J-NZ0488-003-L-Rev0

Otago Regional Council Clarifications

Mine Waste Management Limited (MWM) has provided this letter report to address requests for further information (RFI) from the Otago Regional Council (ORC) received in December 2025 for the Matakanui Gold Limited (MGL) Fast Track Approvals Act (FTAA) application for the Bendigo-Ophir Gold Project (BOGP). Two RFI documents were provided by ORC (reference RMFT25.007):

Figure 1: Ardgour Aquifer mixing calculations.

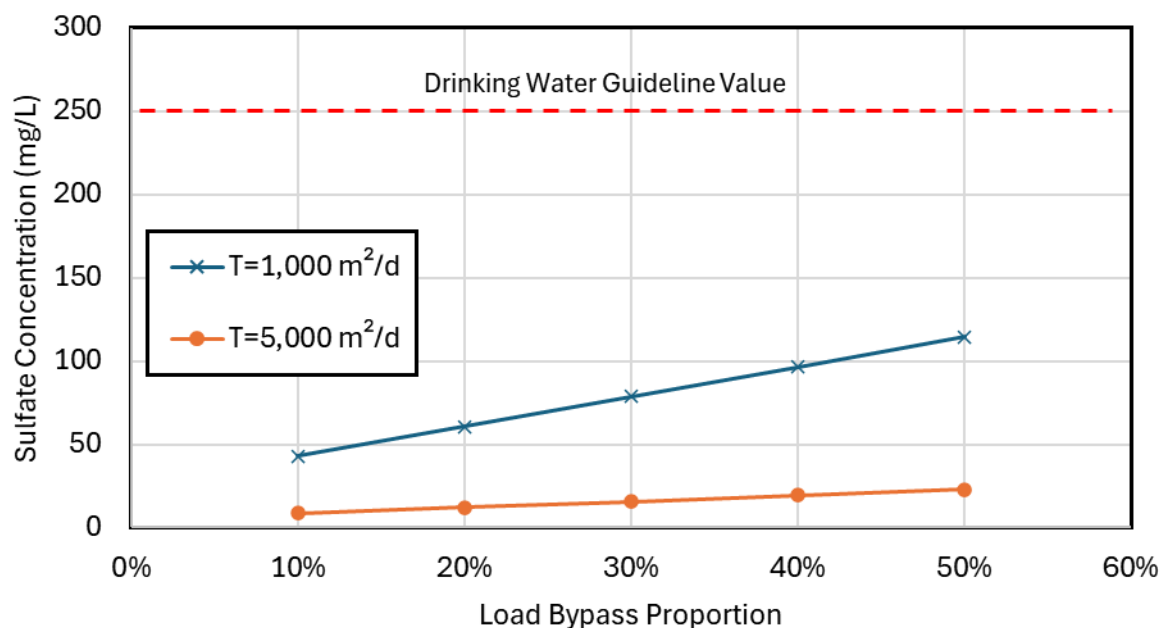
Please undertake sensitivity analysis to understand the potential adverse effects of uncaptured mine-impacted seepage on the downgradient freshwater receiving environment. This purpose of this analysis is to understand the amount of uncaptured seepage (as a percentage of total seepage) from mining features that would result in a measurable adverse effect on water quality within groundwater (the Lindis Alluvial Ribbon Aquifer or Ardgour Valley Aquifer or Bendigo Aquifer) or surface water (Lindis or Clutha Rivers) and any flow-on effects on aquatic ecology in the surface water environment.

Despite the high levels of seepage collection anticipated, screening level sulfate mixing calculations for the Ardgour Valley Aquifer³ for varying levels of seepage collection are calculated as follows (Table 1 summarises the basis for the calculations):

Results are presented in Figure 1 for Shepherds Creek load reporting to the Ardgour Valley Aquifer. Calculations suggest even for relatively high levels of uncaptured seepage bypass (e.g., 50%) reporting to the Ardgour Valley Aquifer, sulfate concentrations are less than half the drinking water guideline value of 250 mg/L. For lower levels of bypass (or high seepage capture rates), say 15% bypass or less, calculated sulfate concentrations are approximately 50 mg/L or less, or lower than the drinking water guideline value by a factor of 5 or more.

Figure 2: RAS Pit Conceptual Model

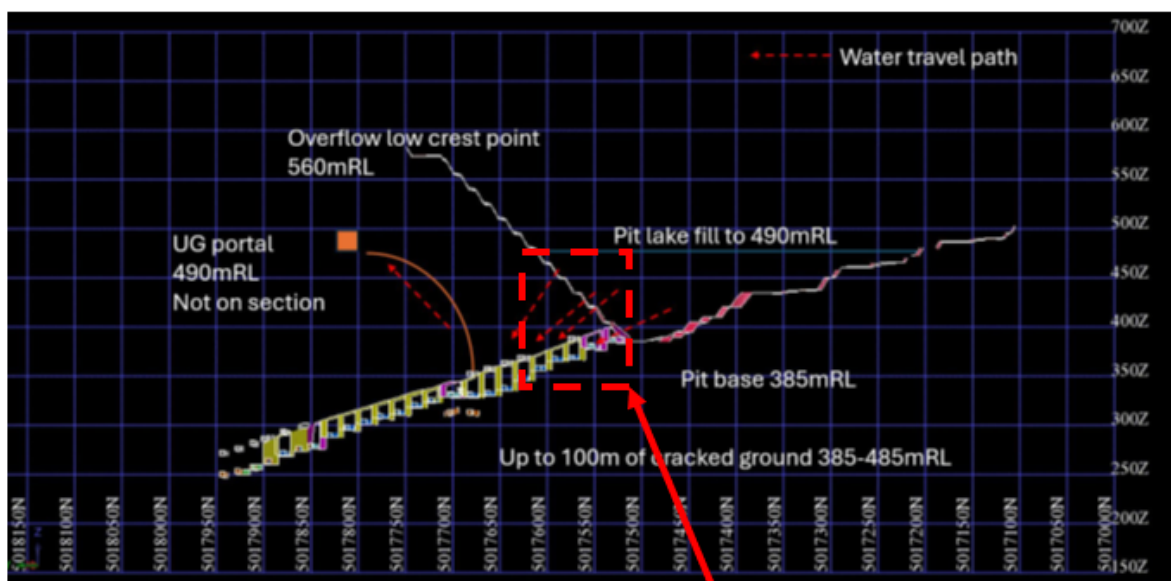
In calculating the source terms for the RAS⁴ underground workings, it has been assumed that water quality is dominated by RAS pit lake quality; however, this does not consider the impact of tailings paste on water quality, nor does it consider the relative volumes that the RAS pit and RAS underground workings will contribute. Accordingly, please:

- a. Compare the expected RAS pit lake water discharge volumes with the expected contribution from the RAS underground workings.
- b. Assess the effect of the discharge of tailings paste into the underground workings on the quality of water in the underground workings.
- c. Recalculate source terms, and update any assessments that rely on these, if necessary.

Paste backfill is likely to have a permeability that is several orders of magnitude lower than the permeability of the (fractured) Crown Pillar that connects the underground to the RAS Pit Lake. Conceptually the water quality will be dominated by the RAS Pit lake water. This is shown in Figure 2.

As the Crown Pillar is robbed, K of overlying rock mass will increase, providing hydraulic connection.

Figure 4: Pit lake filling sensitivity analysis.

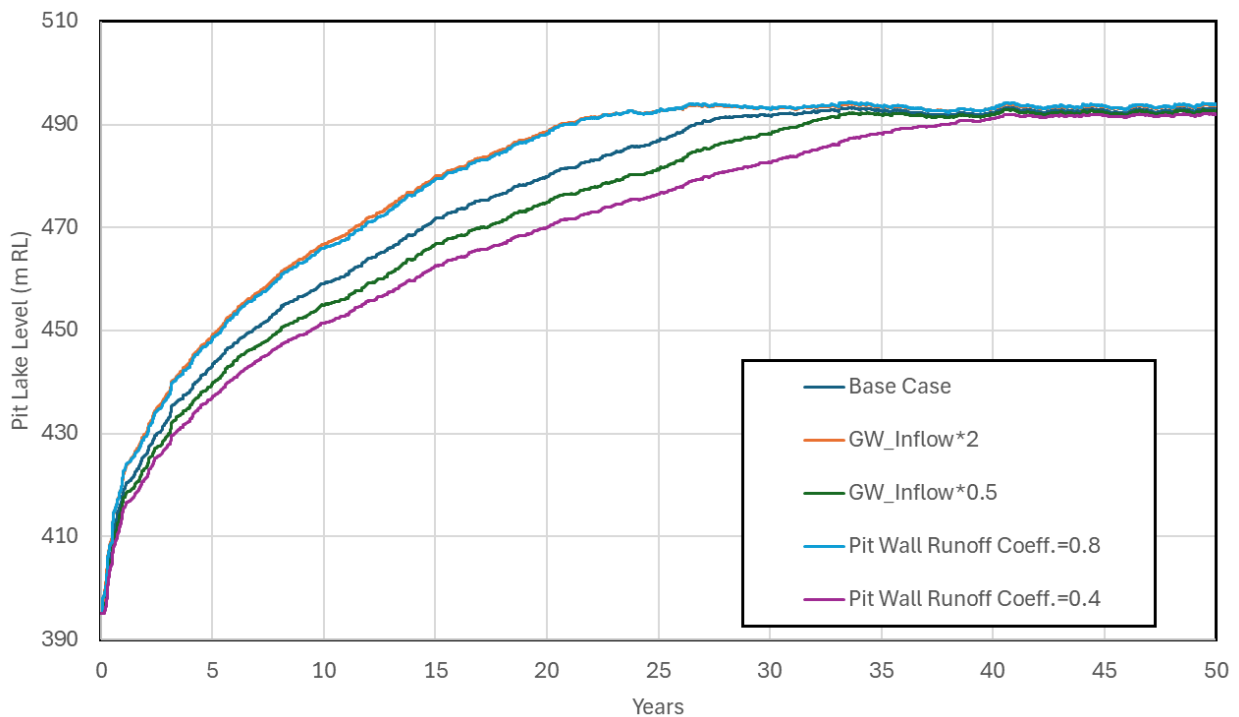
Report B.04 states that an estimated period of 50-60 years will elapse prior to the RAS pit lake and underground workings would connect to the surface water system. Please provide an assessment from a suitably qualified and experienced person that addresses the following matters:

- a. The margin of error in this 50-60-year estimate.
- b. Whether this margin of error has been incorporated into any other assessments that have relied on this estimate, including but not limited to dam⁵ (pit) safety, contaminant transport, downstream ecological assessments, and monitoring and maintenance requirements across the mine site.
- c. ~~How any proposed underdrains have been taken into account in the time estimate⁶.~~
- d. If stream depletion effects are anticipated for 50-60 years post-closure, please explain the reasoning behind Kōmanawa's statement that surface water flows in both arms of Shepherds and Bendigo catchments would increase.

MWM note that Report B.04 uses outdated pit lake filling estimates of 50 to 60 years related to a previously considered portal elevation. The current portal elevation planned is 490 m RL, and modelling completed by MWM (2025b) estimated the filling rate to be 25 years based on this elevation.

Sensitivity analysis of the model developed by MWM is shown in Figure 4 that considers the following scenarios:

As can be seen from the presented analysis, model results suggest the pit lake filling time could vary between 25 to 40 years.

Figure A1: Groundwater - Vertical Hydraulic Gradients
Bendigo-Ophir Gold Project

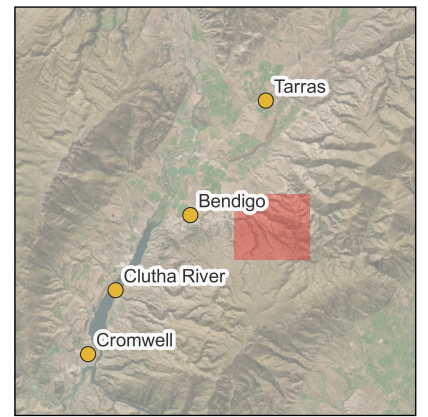
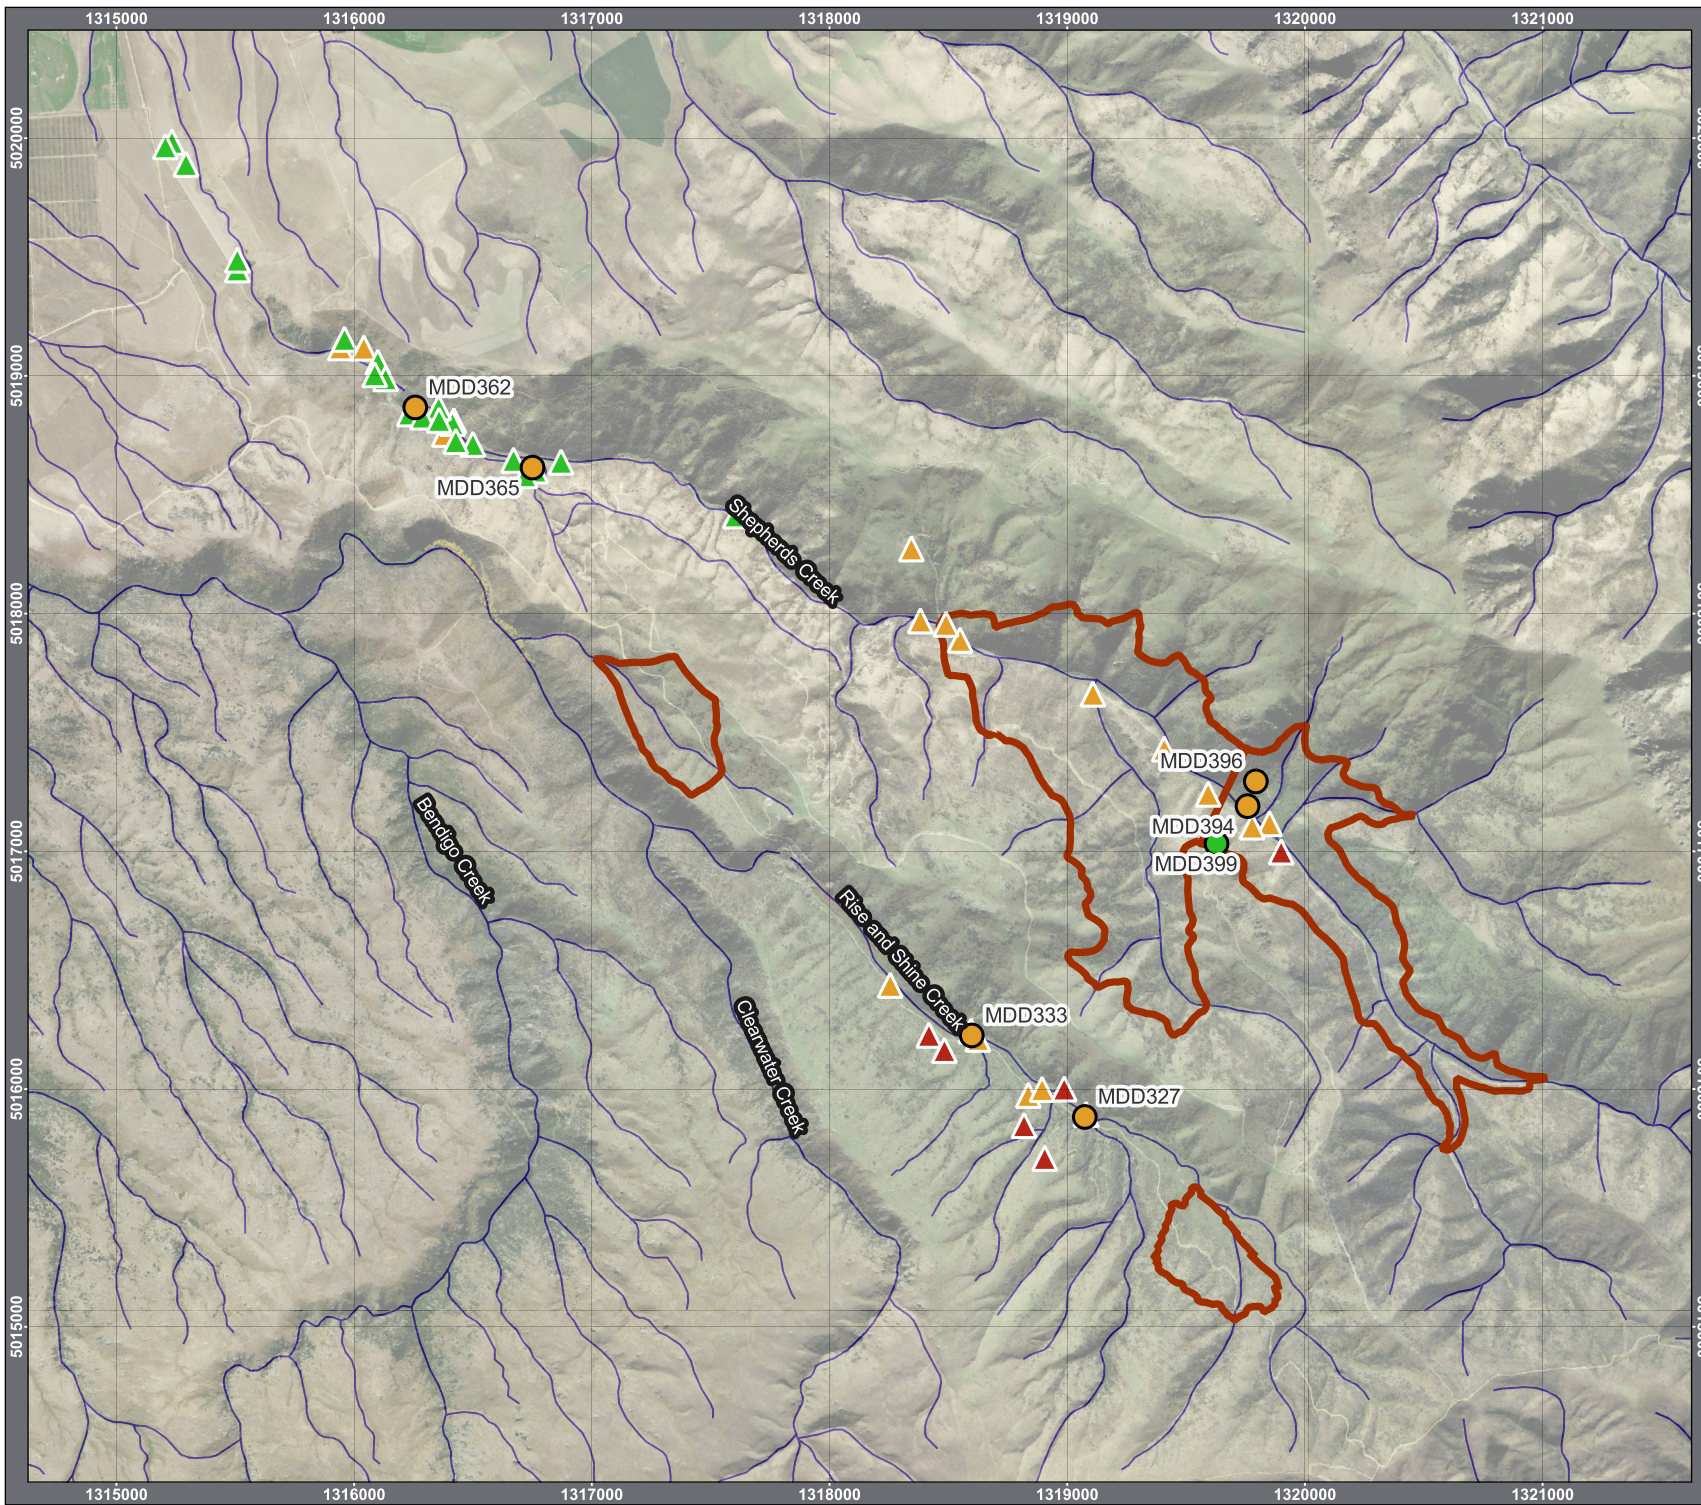
Please provide any additional ground investigation or groundwater monitoring (level or quality) data that has been collected since the MWM and Kōmanawa assessment were undertaken. Please also indicate whether ongoing groundwater investigations and monitoring are occurring, particularly in the vicinity of planned mine waste storage facilities. These data would assist in understanding whether mine waste storage facility seepage collection systems will achieve the anticipated collection requirements. It is noted that MWM recommended that two years of baseline data be collected for a robust data set.

Additional ground investigations have been completed by EGL (2025b). Figure A1 and A2 in Attachment A of this letter report presents salient hydrogeological data from this work that support understanding the hydrogeological setting at the BOGP.
